RE: 716 Site Investigation And Remedial Action Options Report
Bear Development, LLC
Filer & Stowell Property 147 East Becher Street Milwaukee, Wisconsin
BRRTS 02-41-589088

March 29, 2022
Ramboll Project 1690023383

Please find the following response to the DNR's March 21, 2022, email requesting additional information for the Beta-Becher Acquisition Co, LLC (BRRTS case 02-41-589088). The DNR's questions are presented below followed by Ramboll's response (in blue type).

FIGURE 1

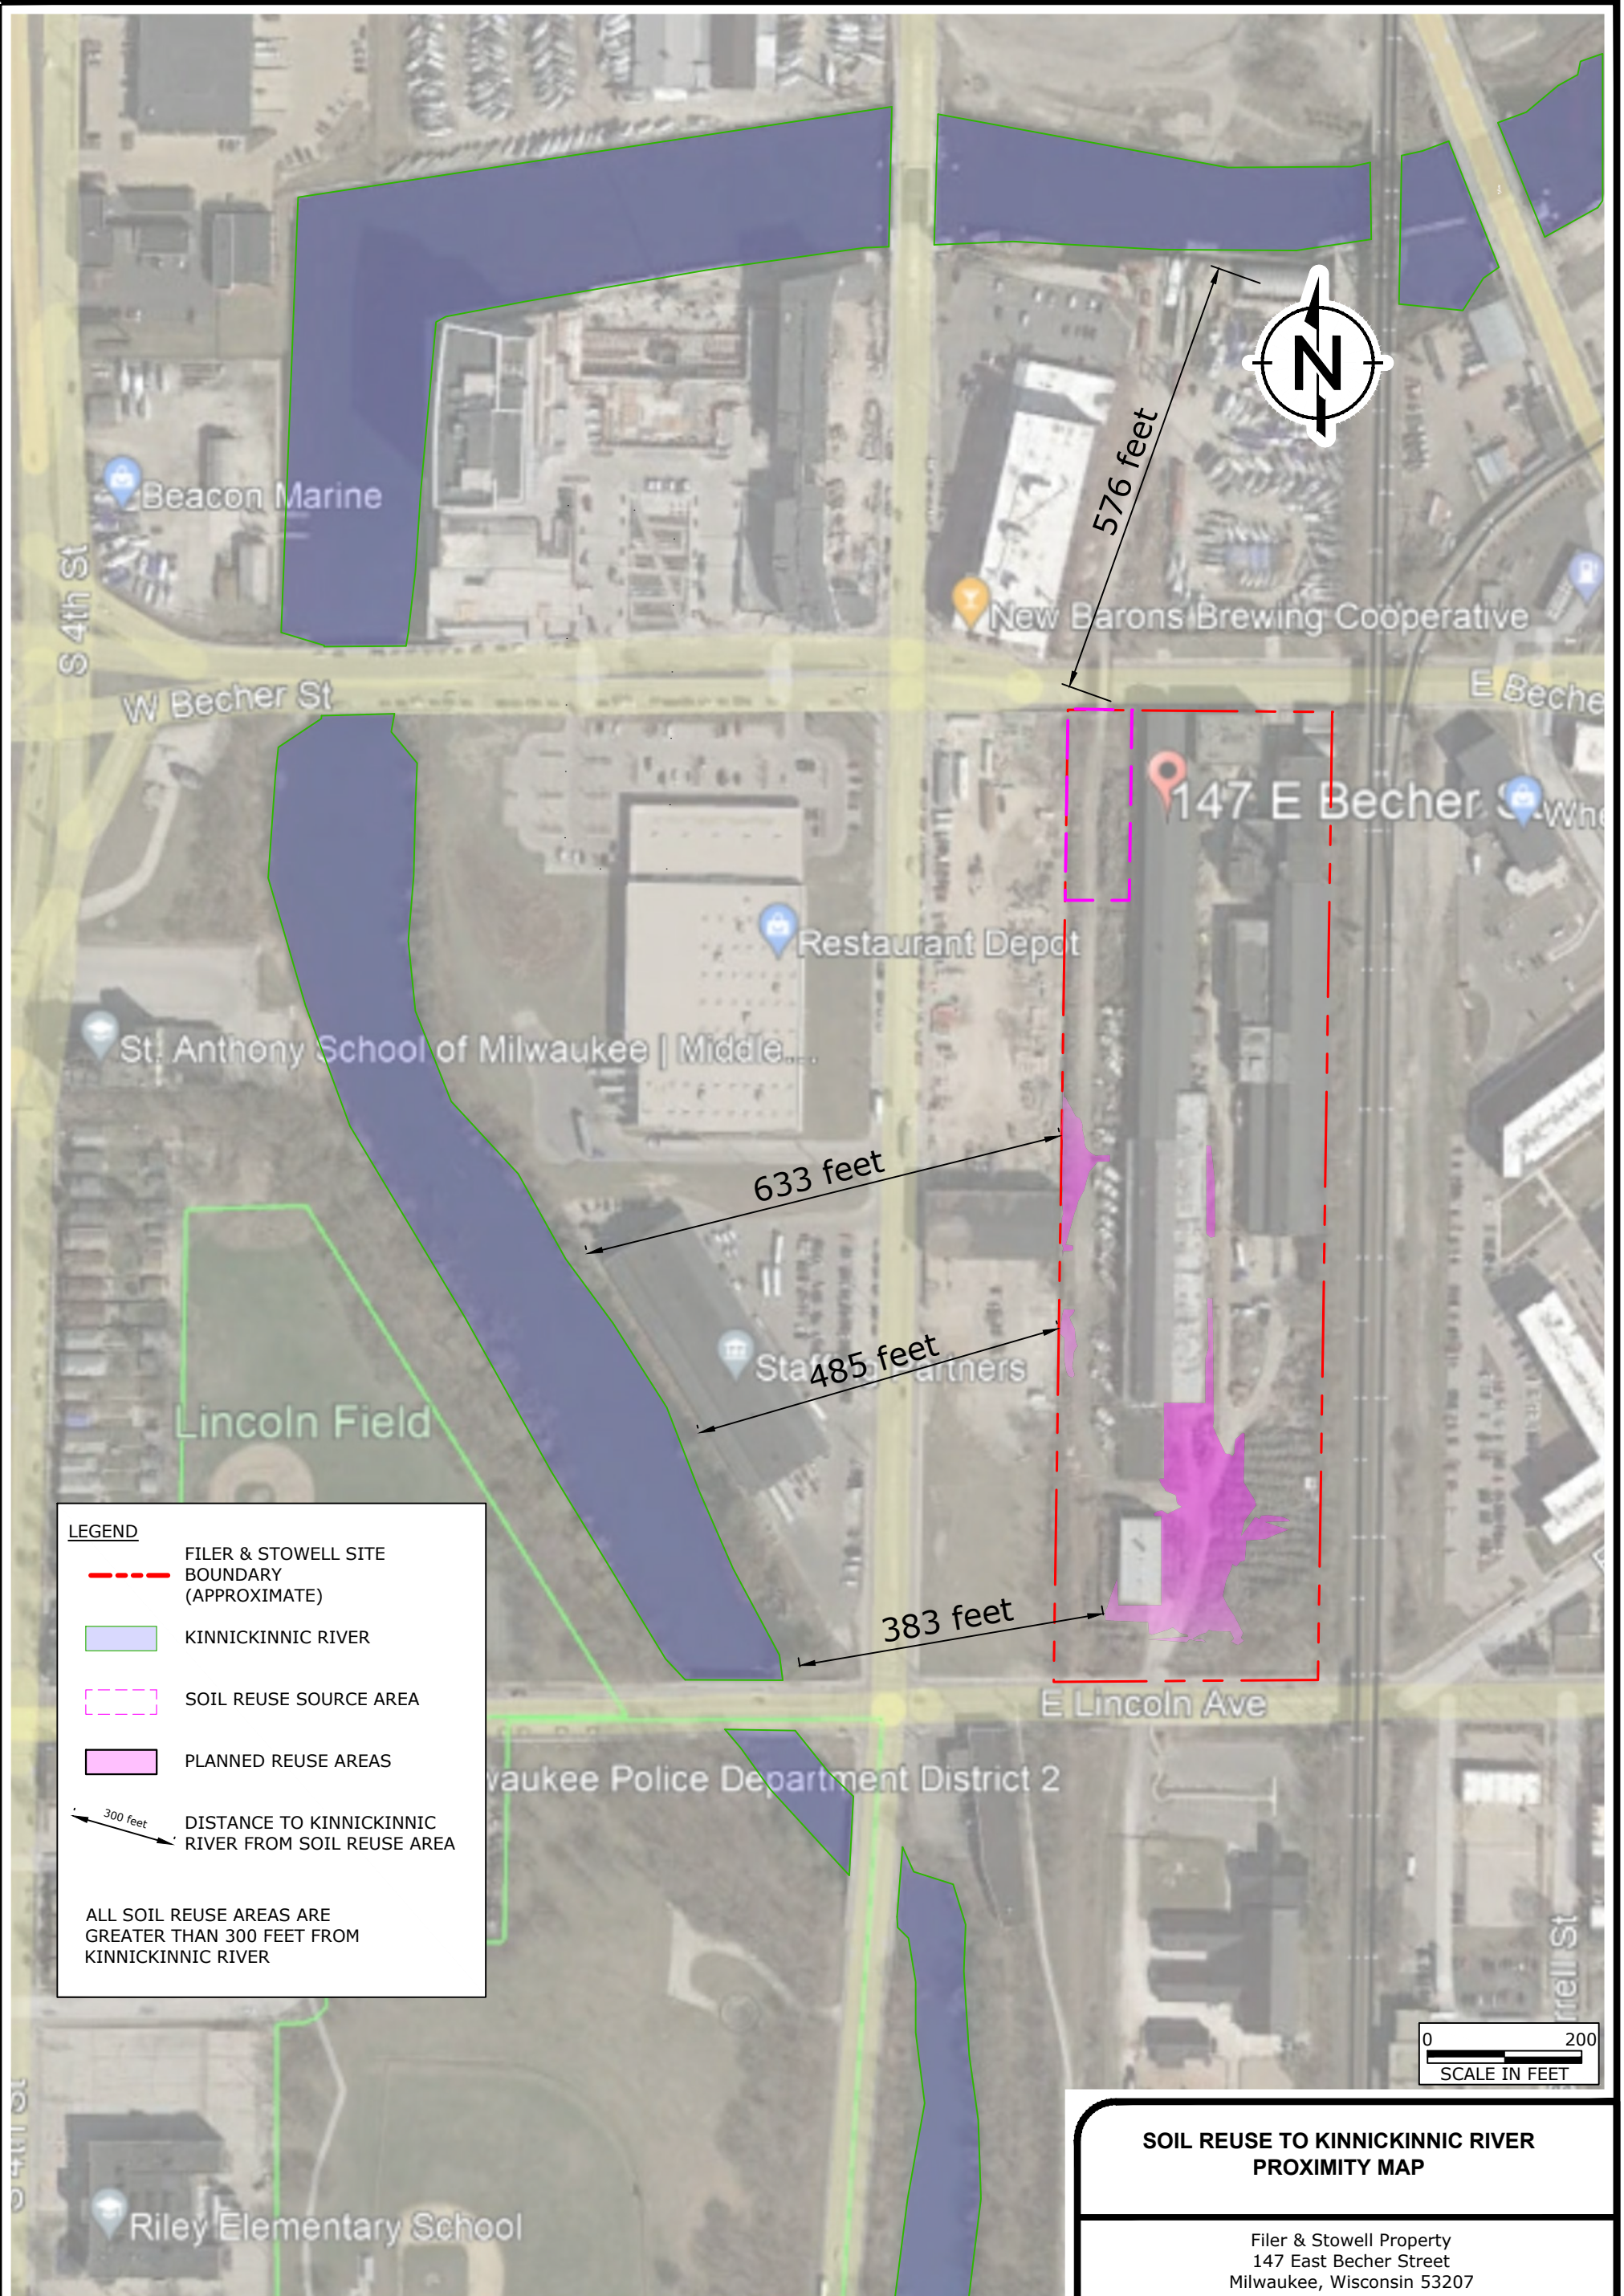
1. *Confirm whether the Kinnickinnic River is within 300 feet of all areas on the site where soil reuse will occur. If so, then an exemption to the locational criteria presented in Wis. Admin. Code § NR 718.12(1)(c) will be required.*

The Kinnickinnic River is more than 300 feet away from all planned soil reuse areas. See **Figure 1** for the site location, planned soil reuse areas, and dimensions from planned soil reuse areas to the Kinnickinnic River. Therefore, Ramboll is not requesting a locational exemption.

FIGURE 3

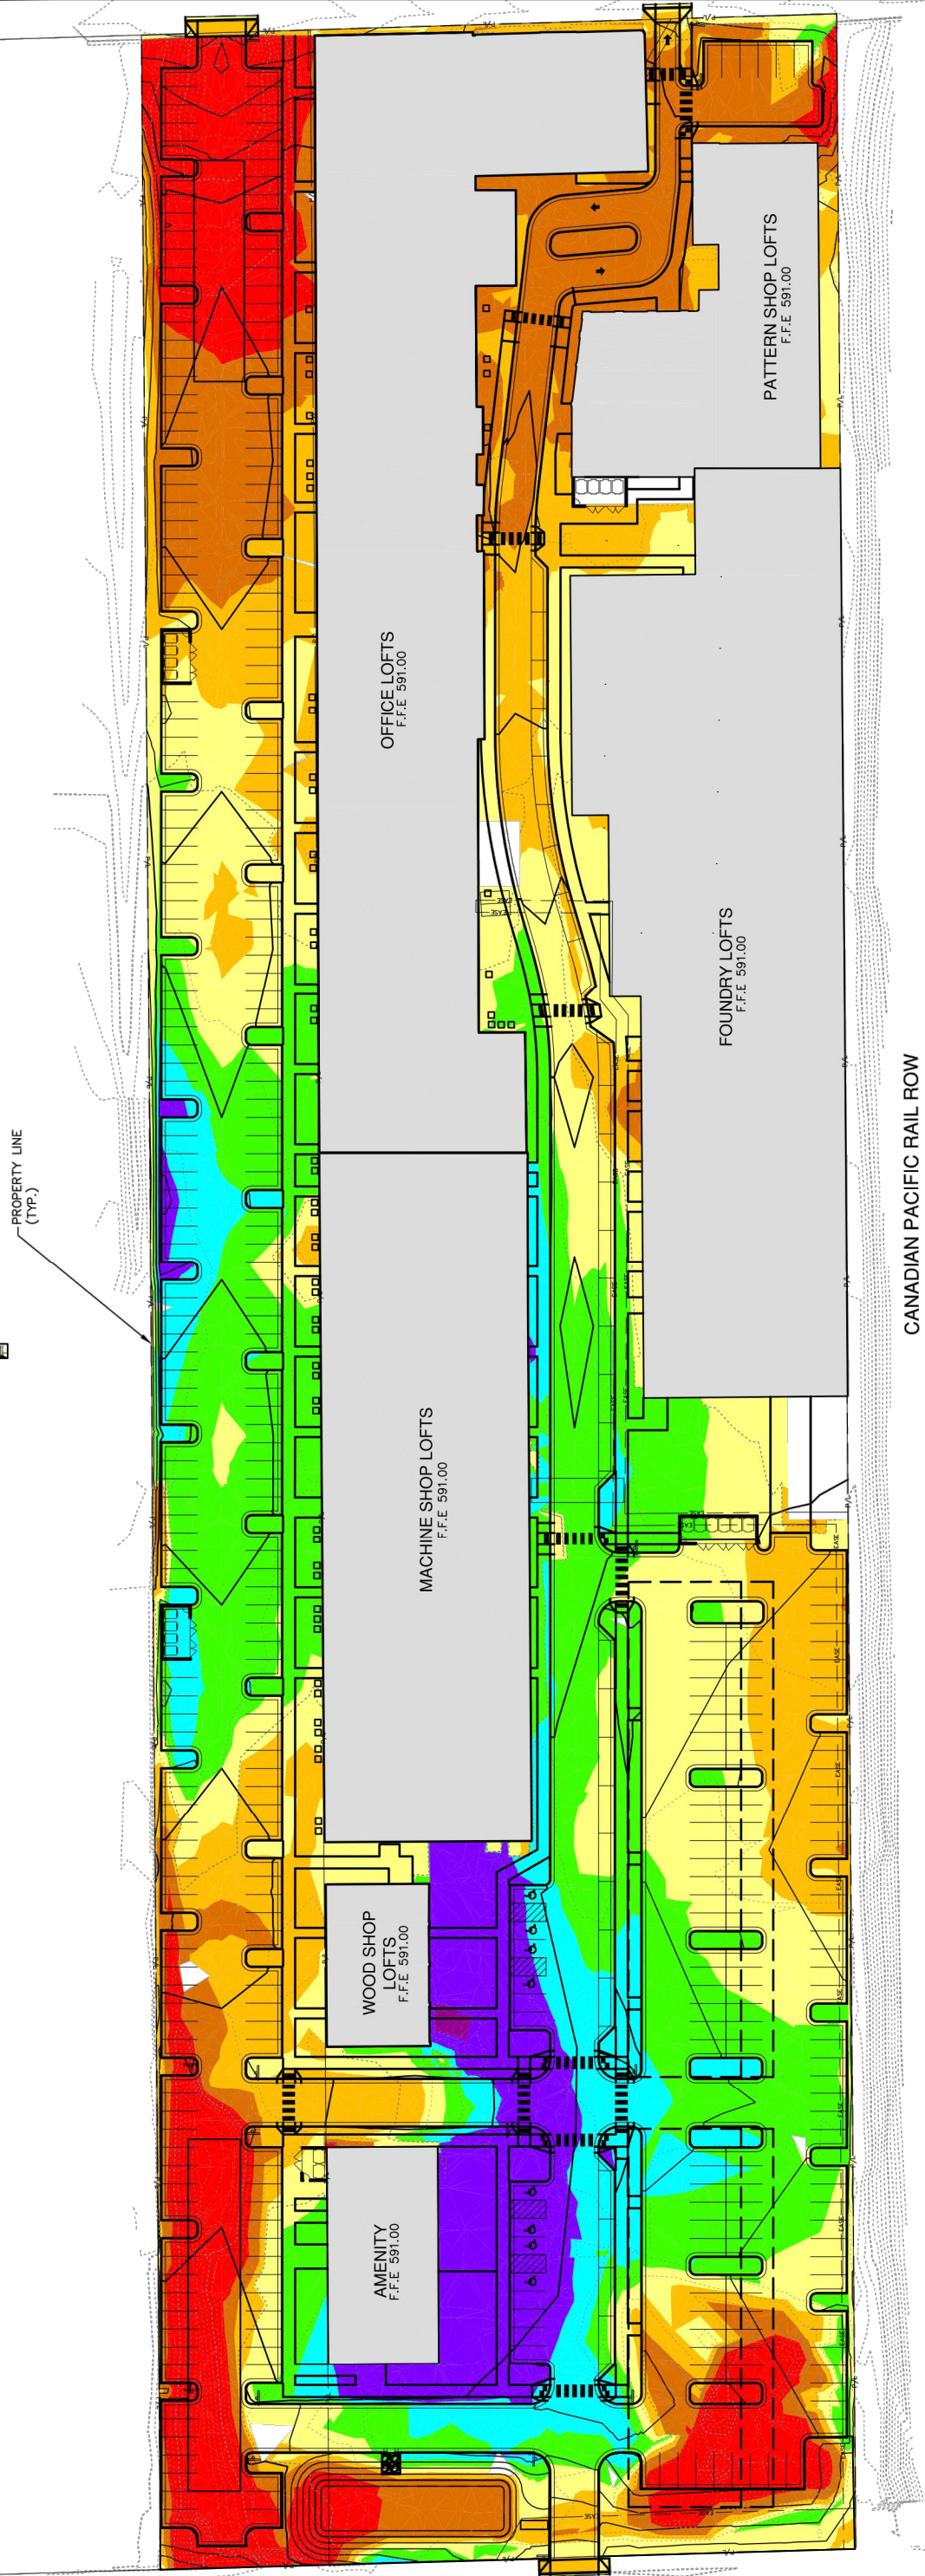
2. *Clarify whether any of the soil to be reused on the site may be placed within three feet (ft) of the highwater level. If so, then an exemption to the locational criteria presented in Wis. Admin. Code § NR 718.12(1)(c) will be required.*

The planned reuse soil will not be placed within 3 feet of the high water table. Note that the groundwater elevation in Wisconsin Administrative Code (WAC) Chapter NR 141 groundwater monitoring well MW-2, which is located within the planned soil reuse area and has the highest groundwater elevation at the site, had groundwater elevations ranging from 4.7 to 4.8 feet below ground surface (bgs). The planned site cut and fill map illustrates that 3 to 5 feet of soil will be placed on top of this area. Therefore, the planned reuse soil will be approximately 4.7 to 4.8 feet above the highest groundwater elevation at the site and not perceived to need a locational exemption. Additionally, the soil placed here shall not pose a threat to public health, safety, welfare, or the environment, based on the soil reuse analytical results. Please find the attached **Figure 2** (Site Layout), **Figure 3** (Cut and Fill Map), and **Table 1** (Groundwater Elevations).
